Planning Commission

Columbia Chevrolet – Final Development Plan Approval 9750 Montgomery Road

September 17, 2021

JOSEPH AUTOMOTIVE COLUMBIA CHEVROLET LOT EXPANSION SITE PLAN

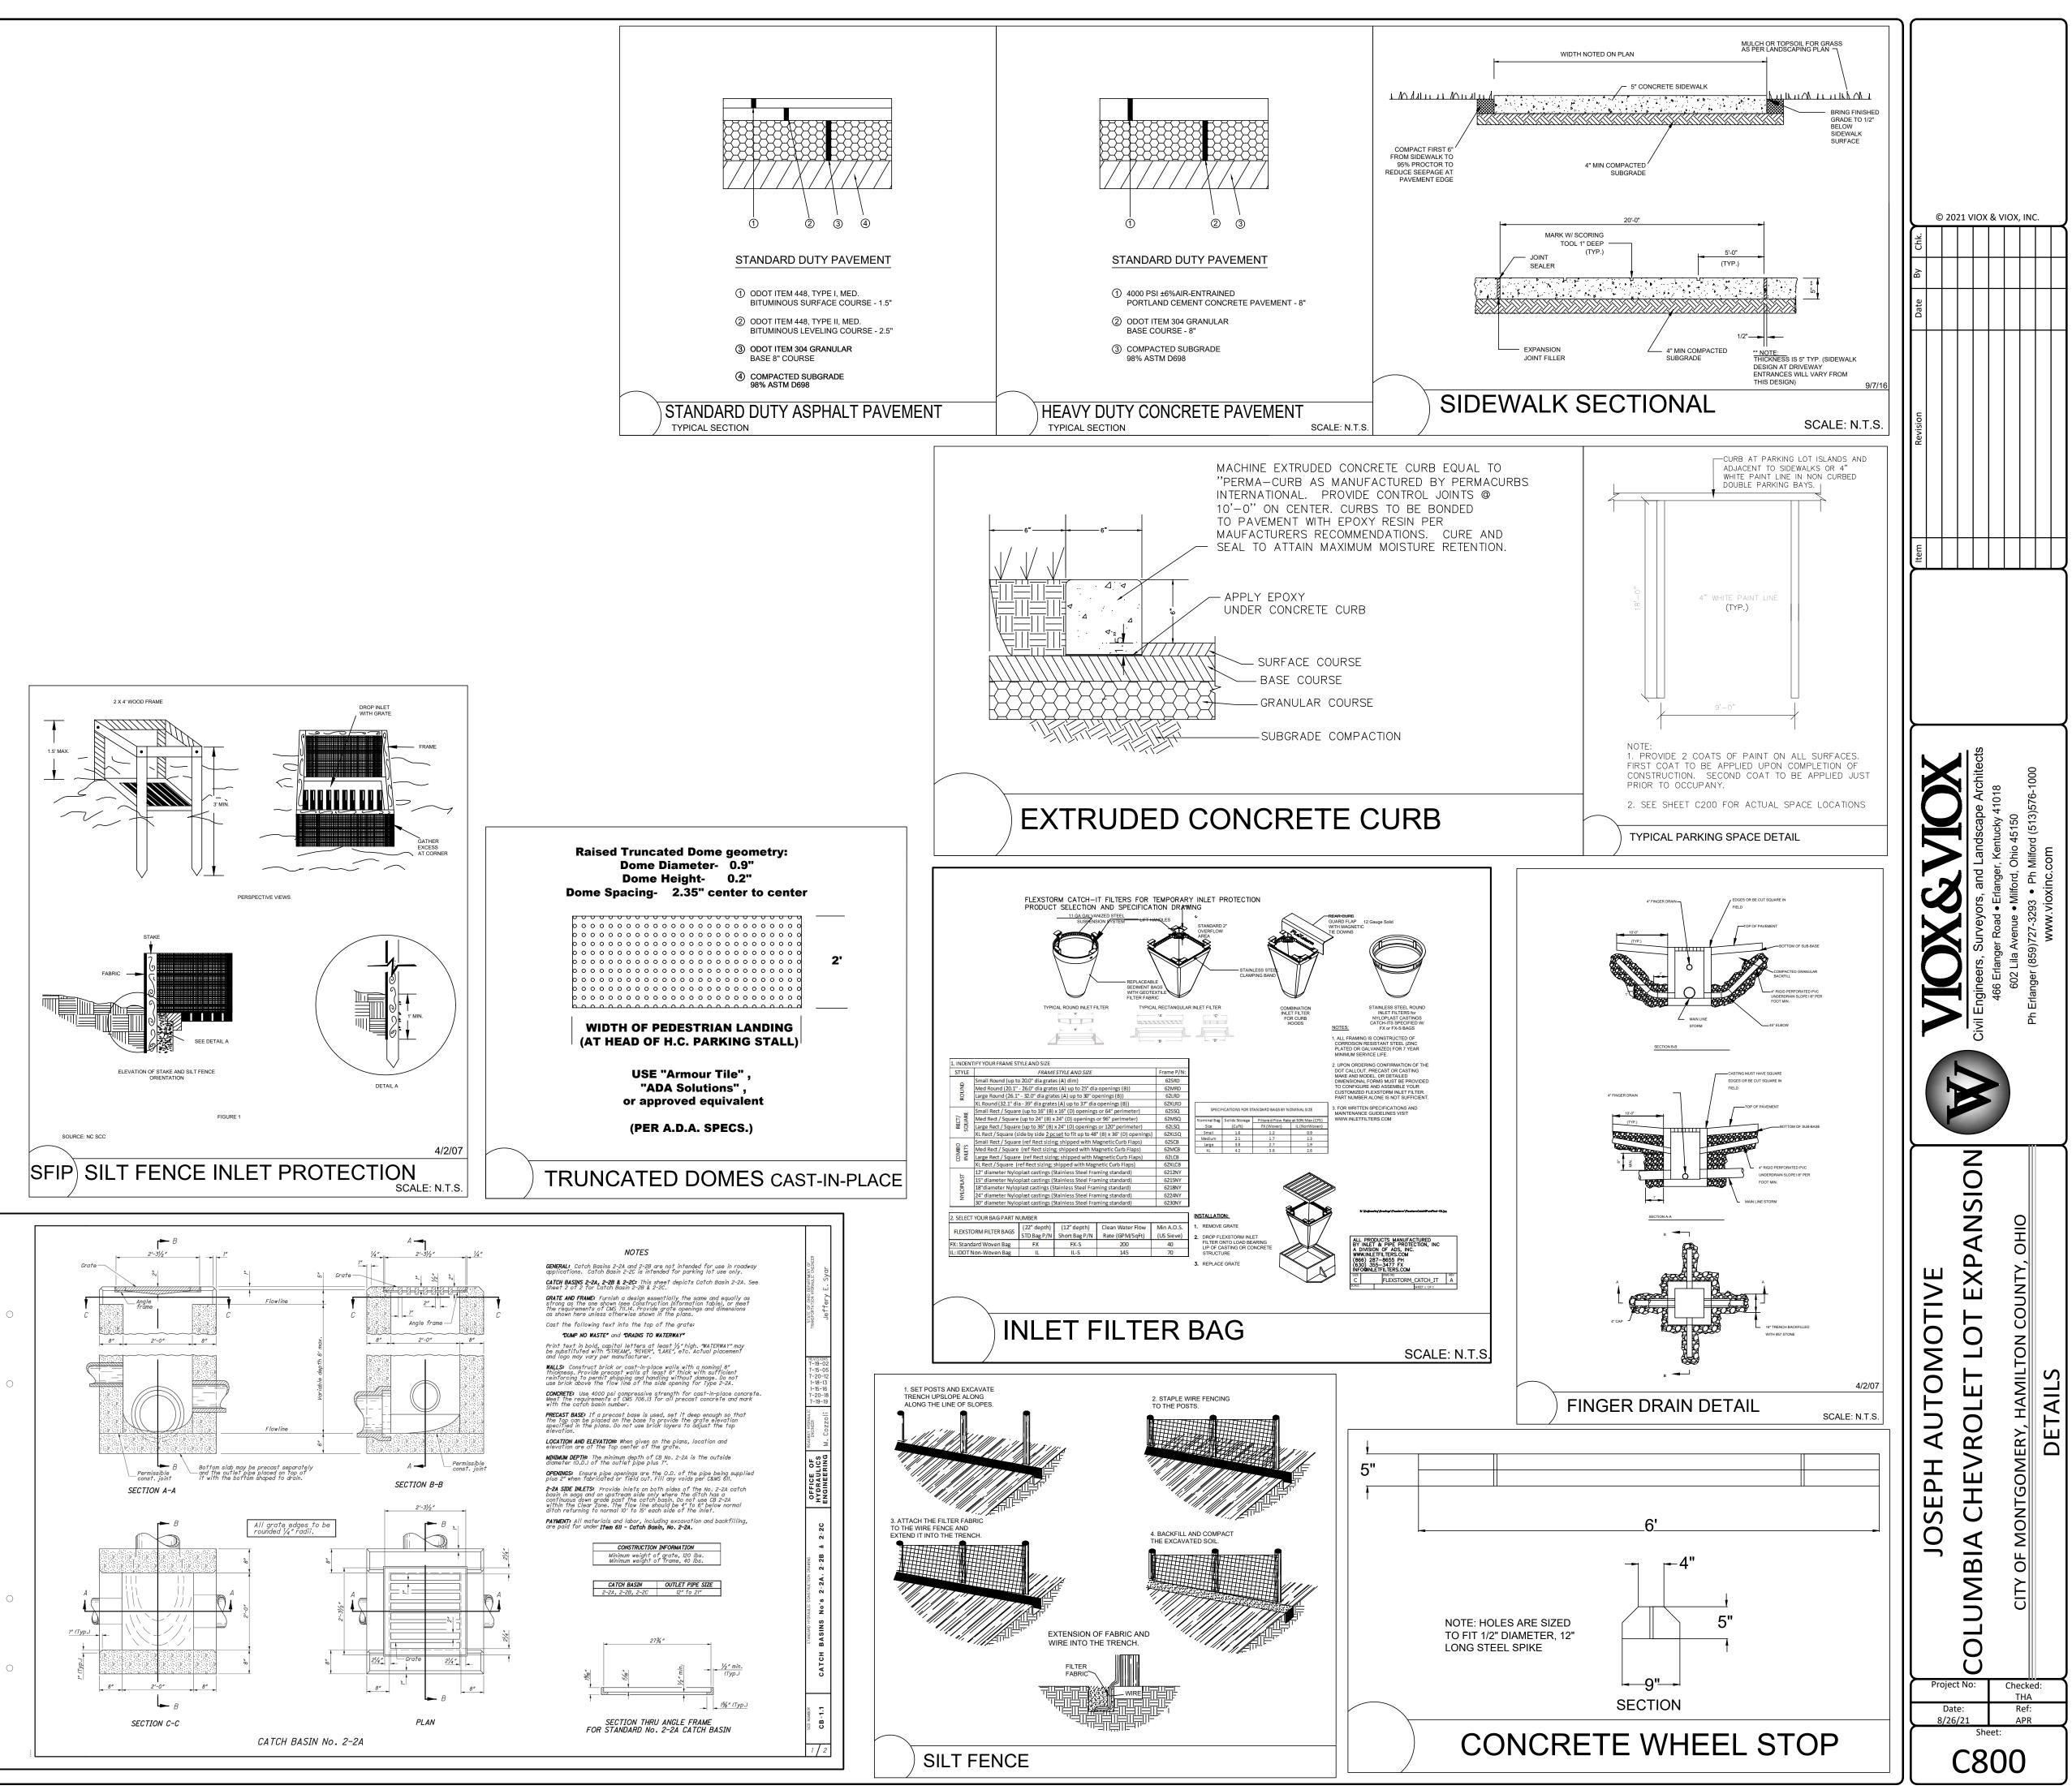
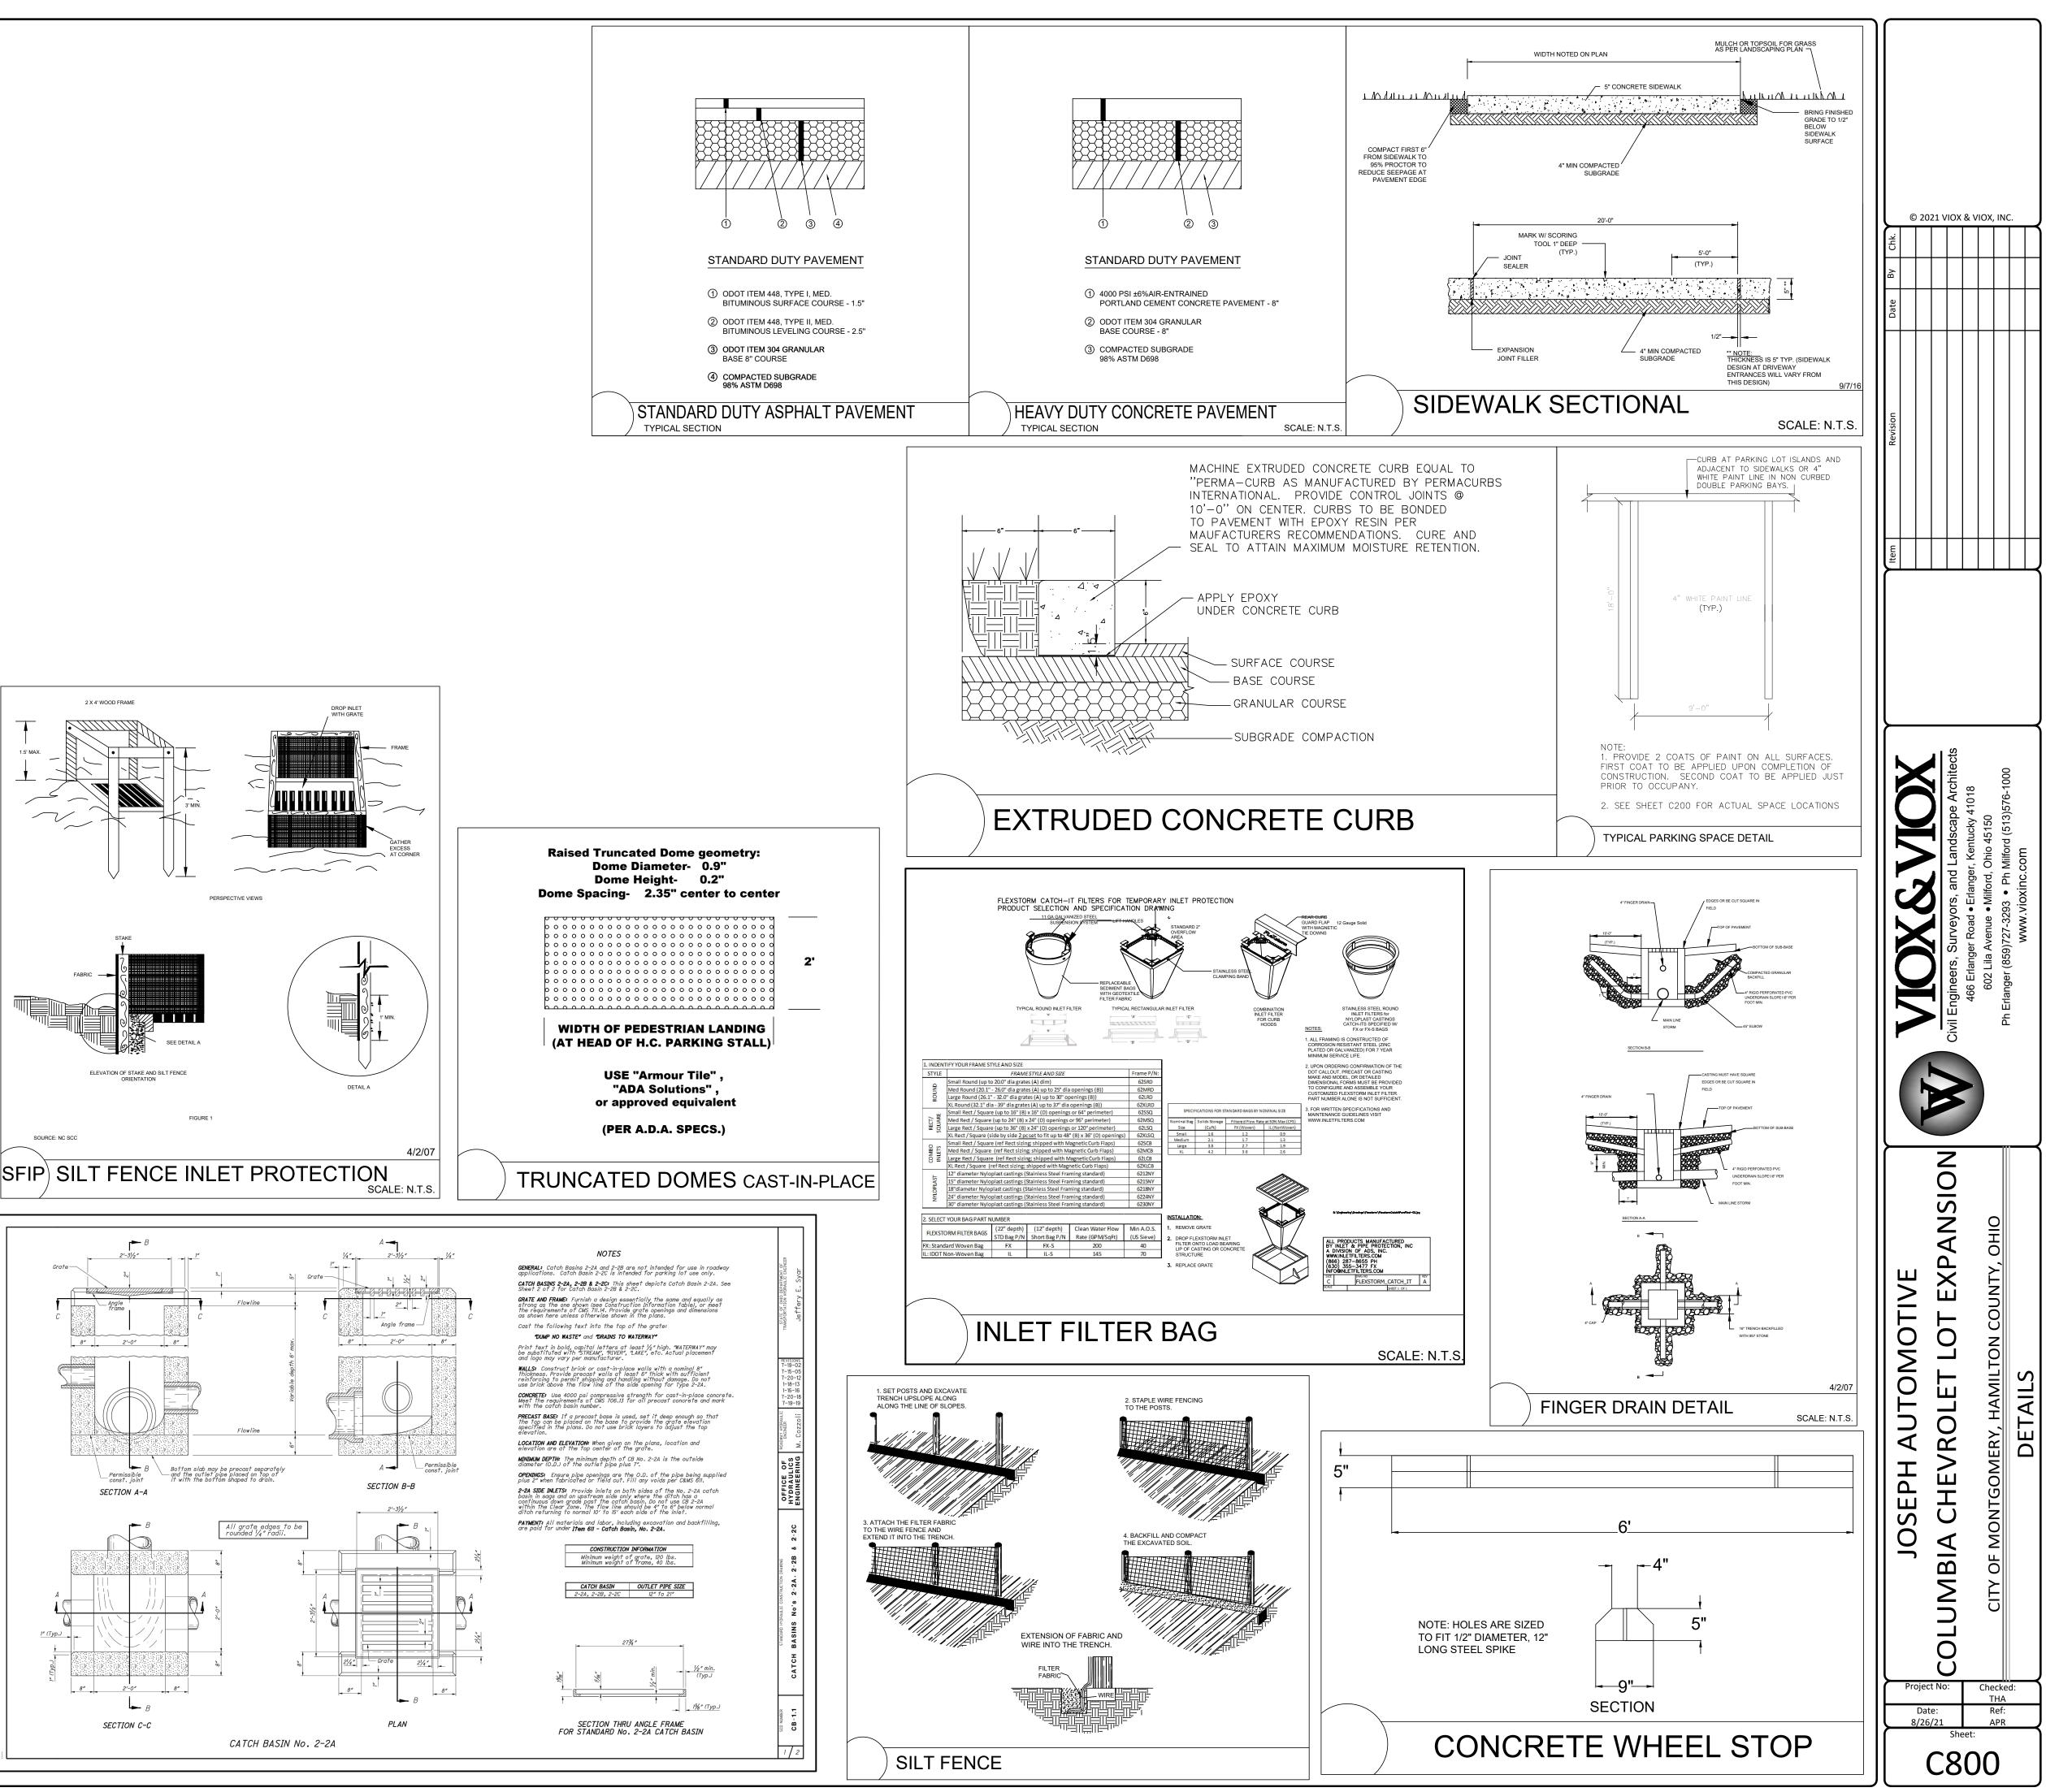
Utilities: Utilities are shown on Page C500 and will be serviced from the existing services. The utilities plan has been sent to the City Engineer for review.

- 1. All conditions approved by the Planning Commission and City Council for the expansion of a conditional use and General Development Plan with an equivalency shall apply.
- 2. The final stormwater, grading and utility plans shall be approved by the City Engineer.
- 3. The final design for the sidewalk shall be reviewed and approved by the City Engineer and the Public Works Director.
- 4. The Final Photometric Plan be reviewed and approved by the Community Development Director prior to issuing any building/zoning permits.
- 5. All light poles to be put on a timer to reduce the average footcandles in the overnight hours as required by Schedule 151.3213(C)(ii).
